Issue	**1**
Factory ID	**25969**
Date of Issue	**01-Jul-2026**

Usman & Sons

Pakistan ACCORD for Health and Safety in the Garment and Textile Industry

Structural Safety Inspection Report

Figure 2.1 - Plan showing approximate location of overstressed columns

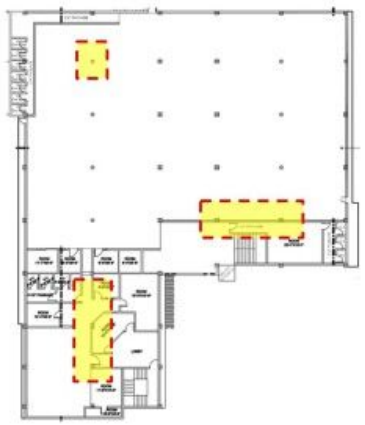
A few interior columns of the main building at the ground floor level appear to be overstressed based on the observed loading conditions. The likely cause of the overstressing is the additional load imposed by the overhead water tank and the additional mezzanine floor.

Column analysis and design calculations were available for a limited number of columns; however, supporting analysis and design documentation for the overhead water tank and the mezzanine floor were not available.F-202605-067251

Timeline	Remediation Plan
Medium Term CAP-0083314	Verify strength of reinforcement through laboratory tensile strength testing.
Medium Term CAP-0083315	Factory Engineer to review design, loads and columns stresses in area identified above.
Longer Term CAP-0083316	Produce and actively manage a loading plan for all floor plates within the factory giving consideration to floor capacity and column capacity.

Figure 2.5 - Approximate location of damaged areas of main building

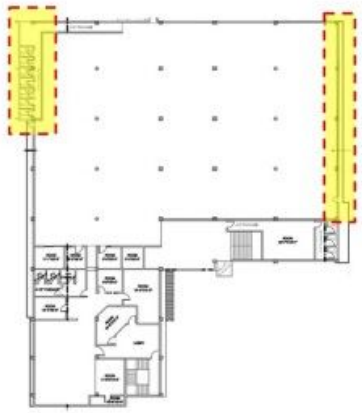
This concern relates to the main building, where slab spalling has been observed at the 1st and 2nd floors, particularly in the toilet areas and slab projections. The likely cause of the spalling is inadequate drainage and water leakage, which may have resulted in deterioration of the slab concrete. F-202605-067303

Timeline	Remediation Plan
Medium Term CAP-0080962	Identify the cause of the damage / source of water ingress and propose measures to prevent further water damage
Medium Term CAP-0080963	Inspect damage to the slab and propose repairs to structure Submit report capturing above to Pakistan Accord for approval
Longer Term CAP-0080966	Implement remedial works
Longer Term CAP-0080967	Continue to monitor for future signs of water ingress/damage

Figure 2.10 - Plan showing location of missing edge protection in main building

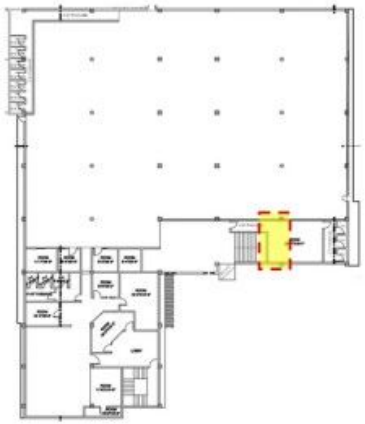
It concerns with inadequate edge protection which present a risk of potential injury resulting from slip, trip or fall from 3rd floor at missing staircase railing during the access and maintenance of services – Health & Safety concern F-202605-067304

Timeline	Remediation Plan
Immediate CAP-0080968	Provide adequate edge protection at staircase on 3rd floor, and on any other part of the factory with the same issue.
